EXHIBIT B

MONTICELLO - SAFETY VALVE SETPOINT INCREASE

Request for Authorization to Change
Appendix A of the Tech Specs, notarized
9-13-73.....W/Attached Rpt, "Monticello -
Safety Valve Setpoint Increase".

PLANT NAME: Monticello

Figure 1

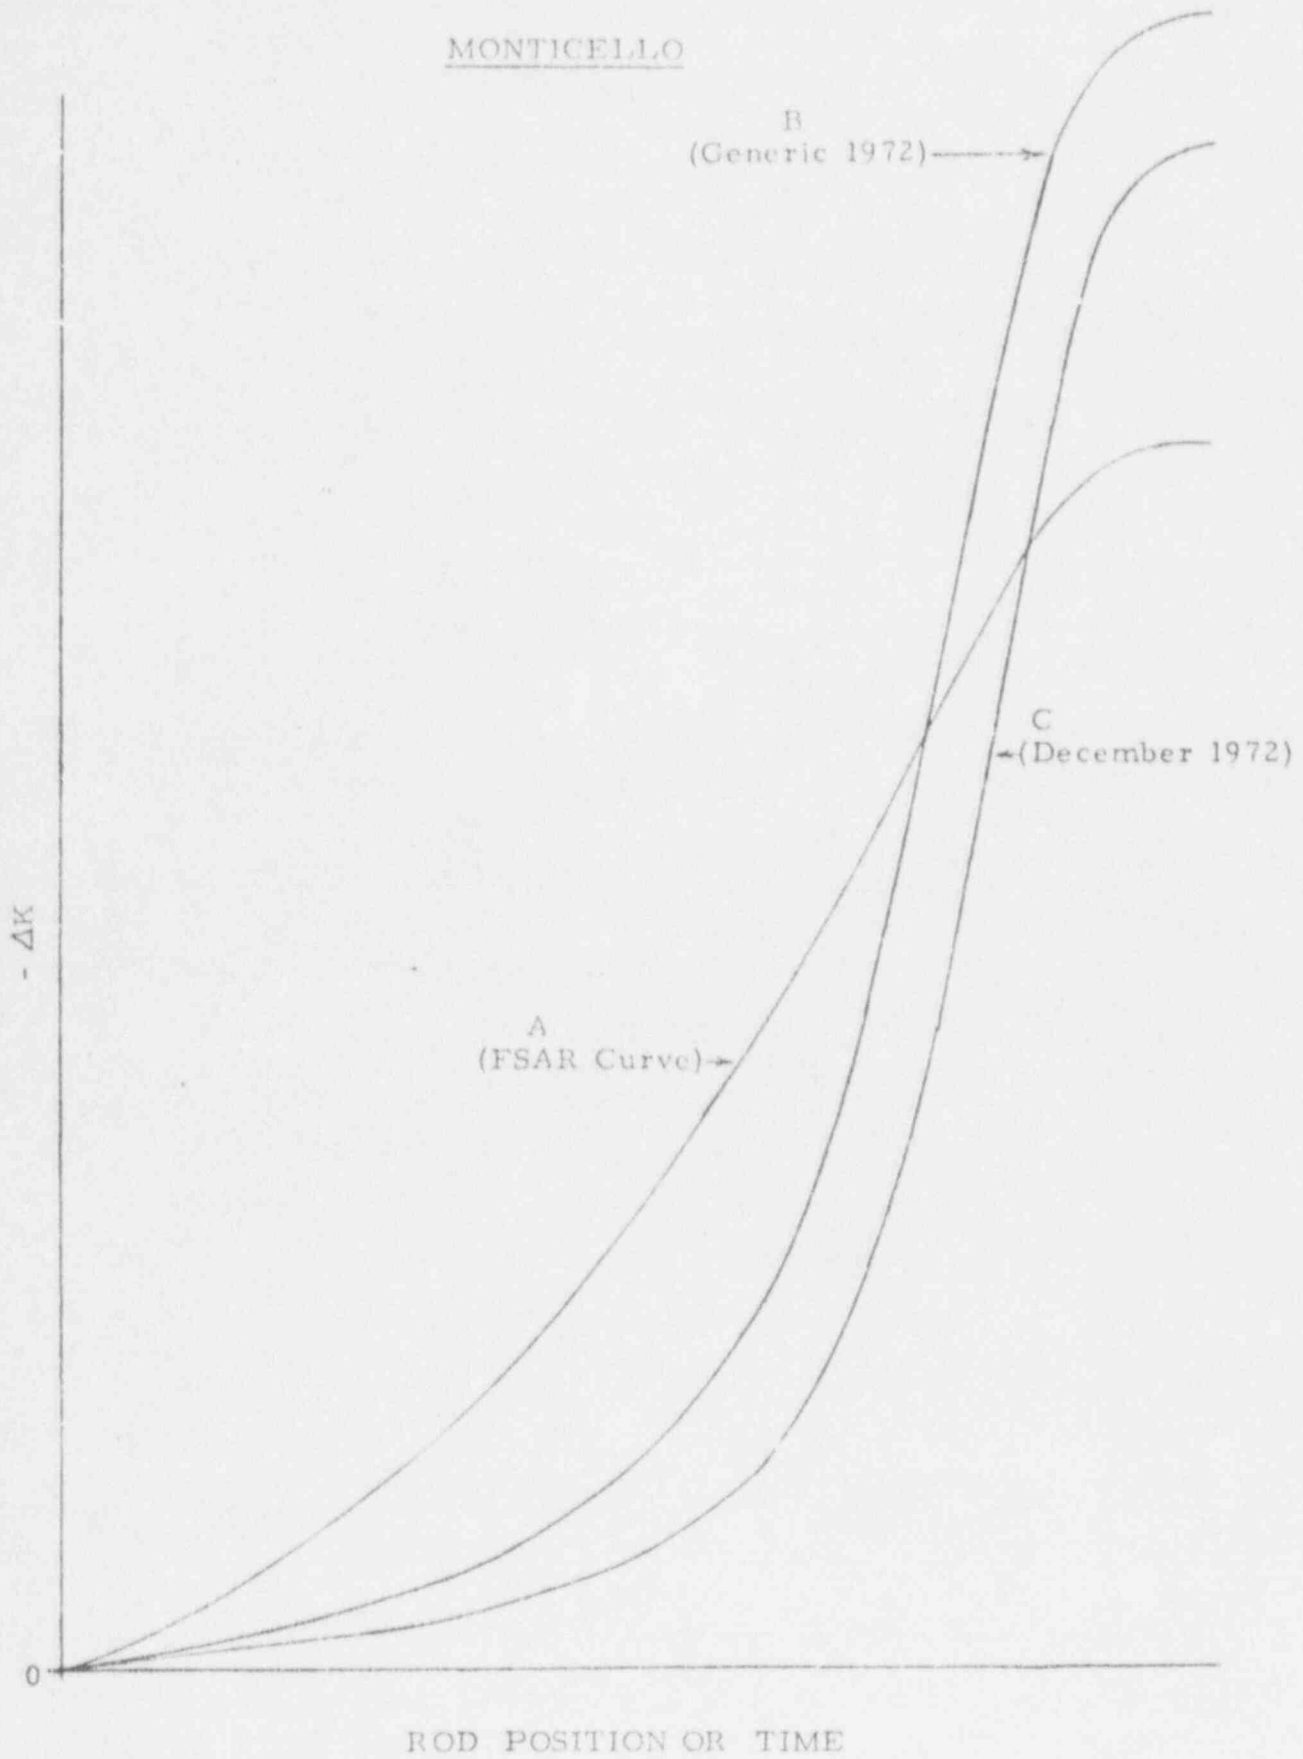
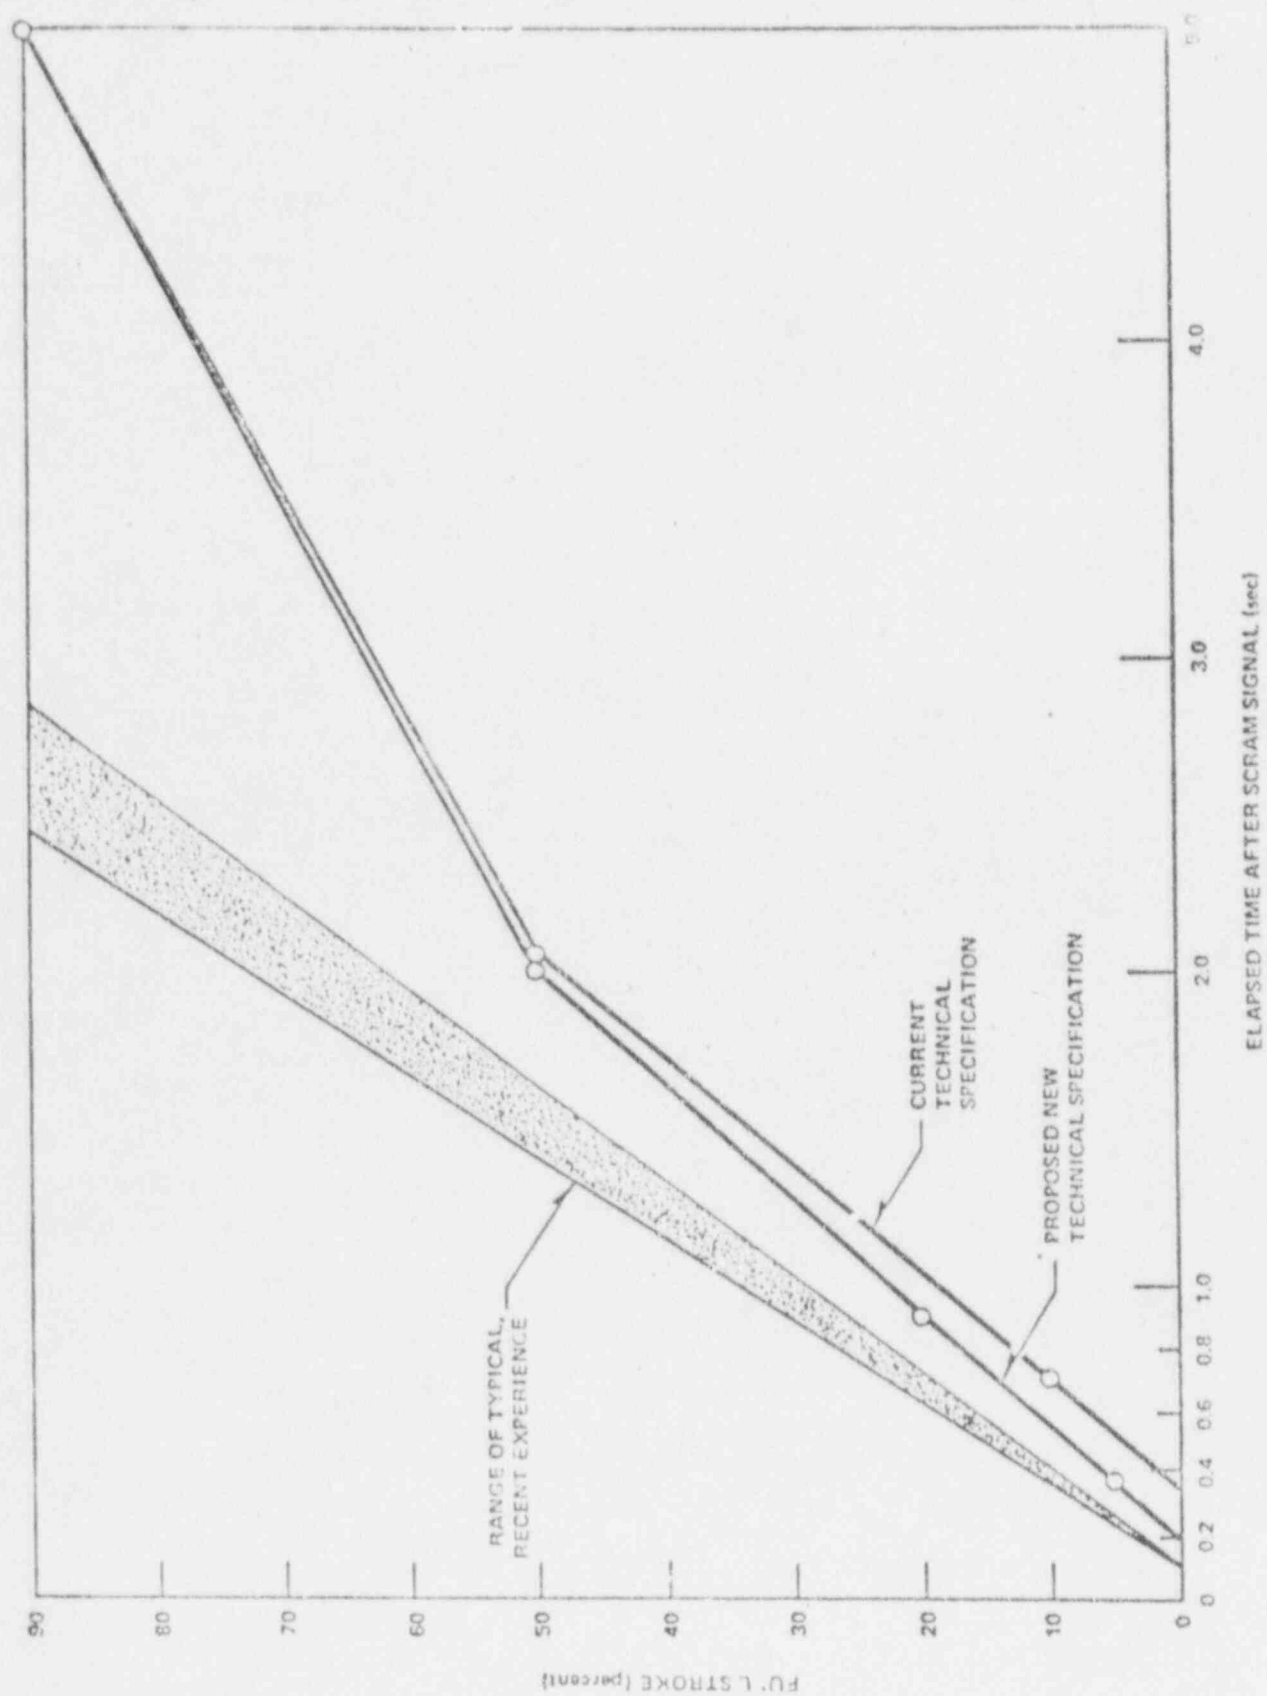
Analysis of the recent change to the exposed core scram reactivity insertion curve (GE December 1972 curve, curve C, Fig. 1) has resulted in the inability of Monticello to satisfy, near the end of cycle, the GE recommended 25 psi margin between the "worst case" pressurization type transient (turbine trip without bypass, i.e., relief valve closing transient) and the setpoint of the first spring safety valve (1210 psig).

General Electric, on the basis of refined analytical techniques, informed NSP earlier this year that the shift in the scram reactivity curve is a function of core exposure, i. e., the present curve (Fig. 1, GE's generic '72, Curve B) does not fully represent the final end-of-cycle core condition. GE has determined that Curve B will define the scram reactivity function to a core exposure (R-1 reload) of 2400 MWD/T. Postulated transients using the assumptions from the analyses and occurring up to that exposure would not result in peak pressures in excess of that described in previous submittals. Beyond an exposure of 2400 MWD/T, additional measures are required to ensure satisfaction of the GE recommended design objective of a 25 psi margin between peak transient pressure and the safety valve setpoints. The margin between peak pressure and the reactor vessel pressure limit following the safety valve sizing transient (MSIV closure) remains well above the 25 psi required design margin; therefore, no safety limit is affected whether or not additional measures are taken.

General Electric has determined an "all rods out" scram reactivity curve (Fig. 1, Curve C) to define the worst case core conditions between 2400 MWD/T and the end of the current cycle for Monticello. Although actual conditions do not reach Curve C until the all-rods-out end-of-cycle exposure, Curve C was applied to determine what measures were necessary to ensure maintenance of the effects of transients throughout the remainder of the cycle in conformance with the earlier analysis.

The setpoints of all four spring safety valves can and should be reset to 1240 psig prior to a core exposure (R-1 reload) of 2400 MWD/T. This setpoint increase can be effected within appropriate codes and regulations, and maintains the required and recommended margins described in earlier documents.

Figure 3

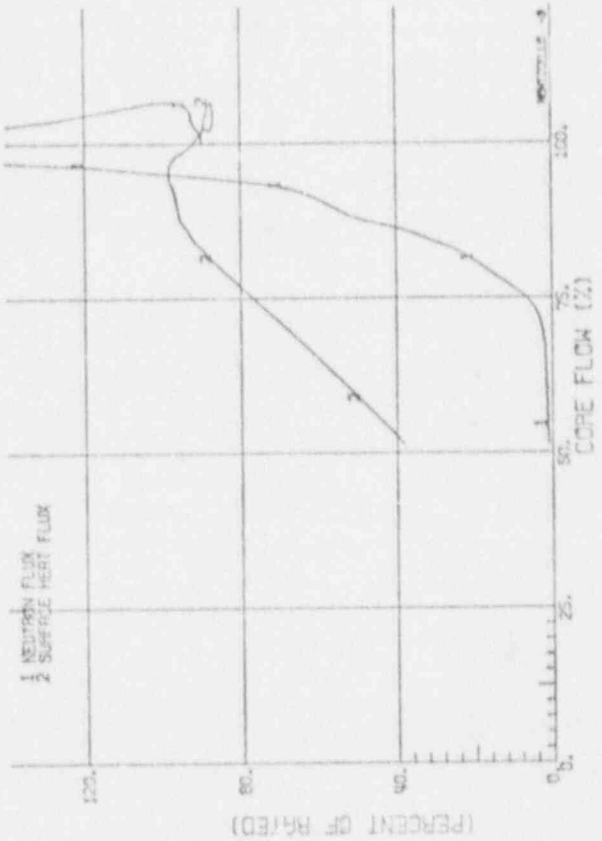
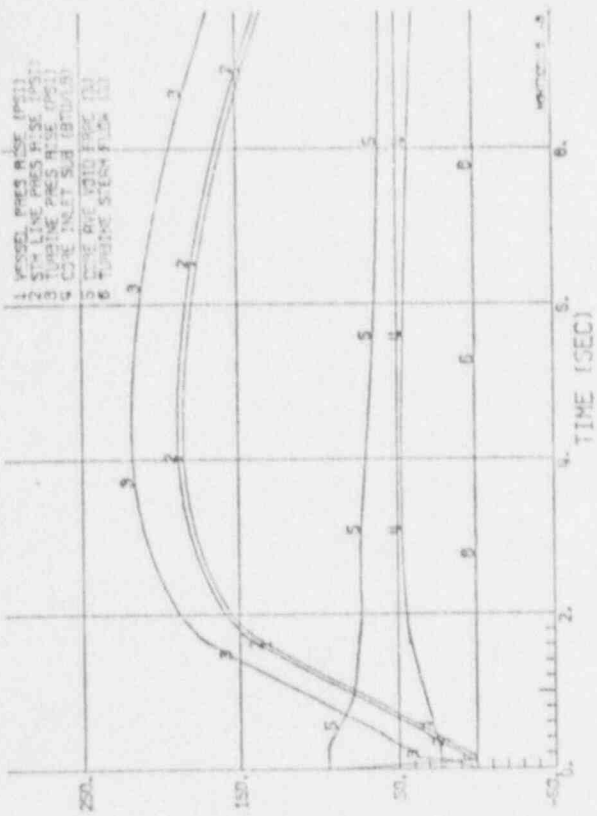
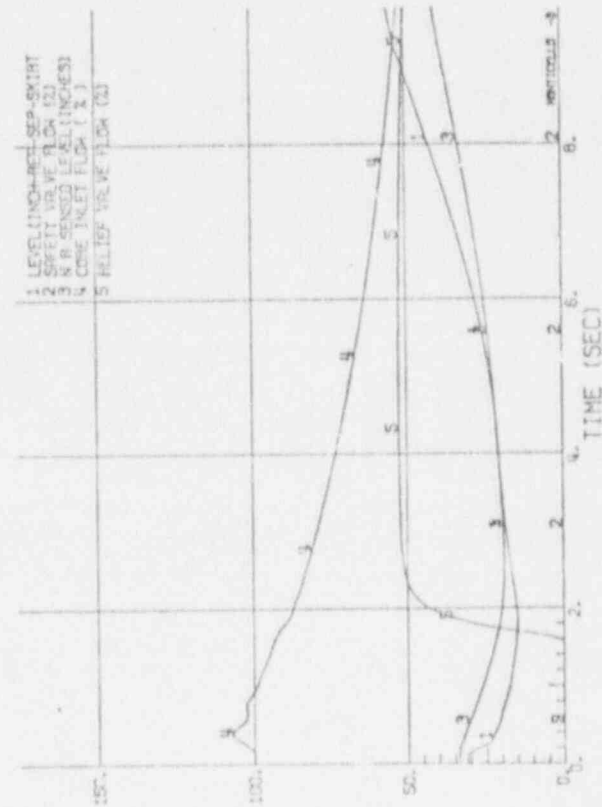
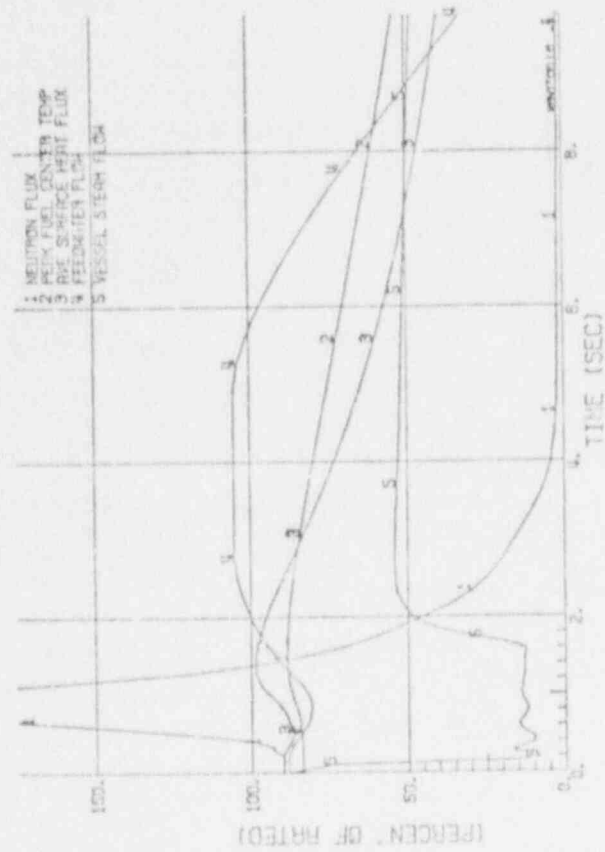
rapid closure (0.10 sec.) of the turbine stop valve without bypass operation causes core voids to collapse and neutron flux peaks at 262 percent of design in 0.92 sec. (Figure 3) before the scram shuts down the reactor. Peak surface heat flux is 100.3% at 1.36 sec. MCHFR and other pertinent parameters remain within acceptable limits.

Figure 4

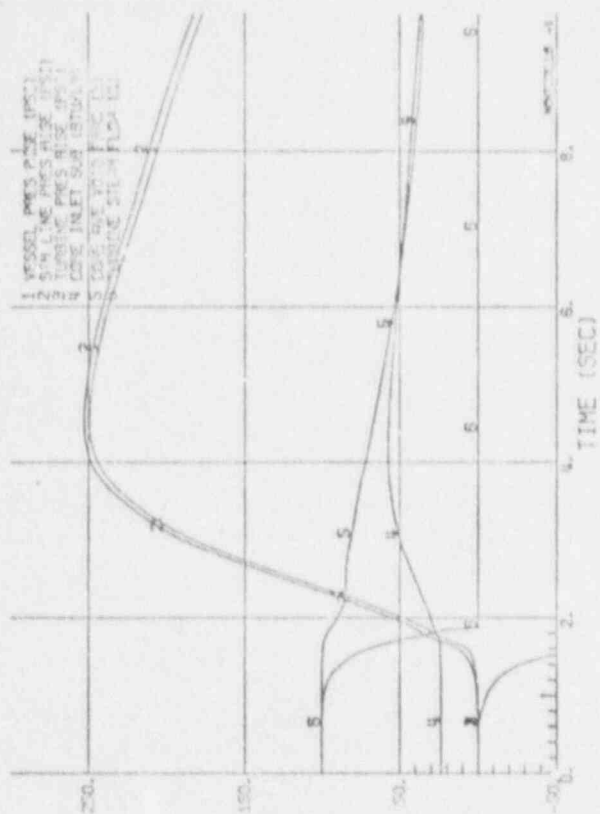
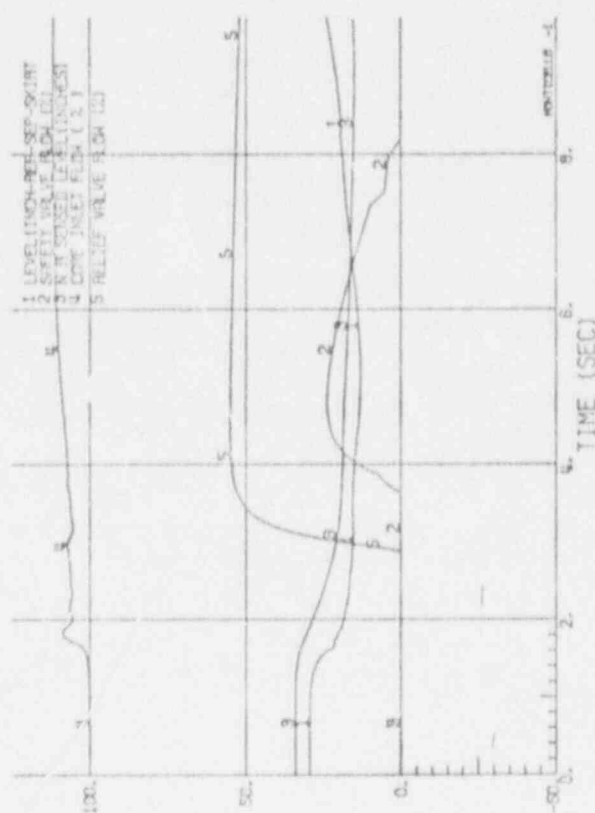
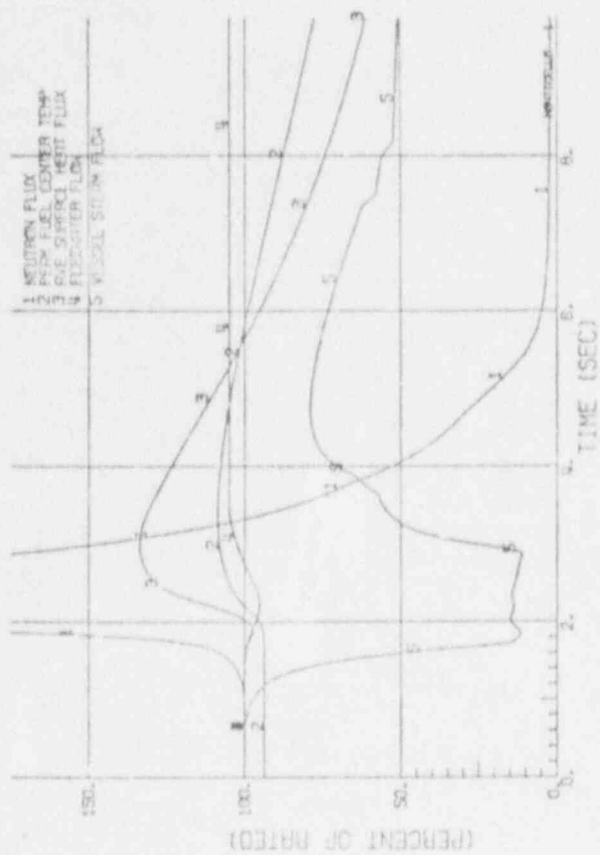
The resulting transient assuming the capacity of the 4 safety/relief valves (47% of main steam generation rate) and the 4 safety valves (36.9% of main steam generation rate) is shown in Figure 4. An abrupt pressure and power rise occurs as soon as the isolation becomes effective. Neutron flux causes the scram at approximately 1.8 seconds thereby initiating reactor shutdown. Flux peaks at a value of 644 percent in 2.14 sec. The assumed safety valve capacity (Target Rock plus spring safety capacities) keeps the peak vessel pressure 67 psi below the peak allowable ASME overpressure of 1375 psig. Therefore, the relief valves plus the spring safety valves provide adequate protection against excessive overpressurization of the nuclear system process barrier with an adequate margin.
